**PLANNED UNIT DEVELOPMENT  
& SUBDIVISION STAFF REPORT****Date: August 8, 2013****DEVELOPMENT NAME**

Cosgrove Subdivision

Planned Unit Development Approval to allow reduced side  
yard setbacks for a proposed subdivision, and Subdivision approval to create 13 lots.

## SITE PLAN

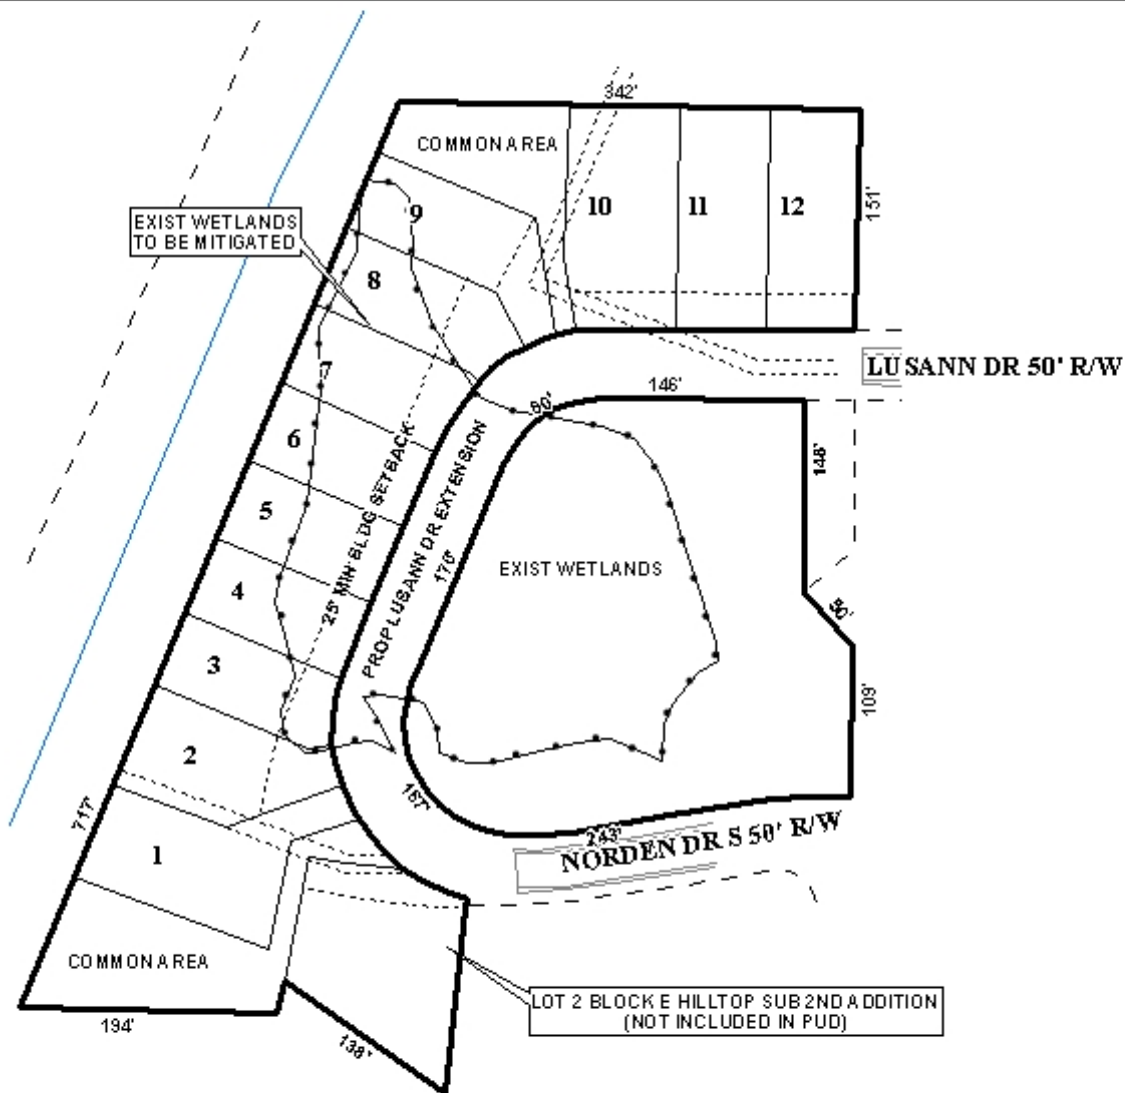
It should be pointed out that Lot 12 abuts an existing, developed lot. Typically the side yard setback in PUDs is required to be at least 8 feet where the PUD abuts existing residential development. Therefore, a side yard setback of 8 feet should be required along the East boundary of Lot 12.

As the site abuts the floodway and drainage easement for Twelve Mile Creek, safety is of concern. A six-foot high wooden privacy fence should be placed along the rear of Lots 1-9, where they abut the floodway and drainage easement for Twelve Mile Creek. The fence should be provided as each lot is developed, subject to Engineering approval due to possible drainage issues.

- 1) Depiction and labeling of the front (25 feet +), side (5 feet) and rear (8 feet) setbacks for all lots, with the exception of Lot 12, which will have a side yard setback on the East boundary of 8 feet, and a side yard setback of 5 feet on the West boundary;

- 4) Labeling of each lot with its size in square feet, or placement of a table on the plat with the same information;
- 5) Revision of the site plan to depict and label the provision of a six-foot high wooden privacy fence placed along the rear of Lots 1-9, where they abut the floodway and drainage easement for Twelve Mile Creek, to be constructed as each lot is developed, subject to Engineering approval due to possible drainage issues;
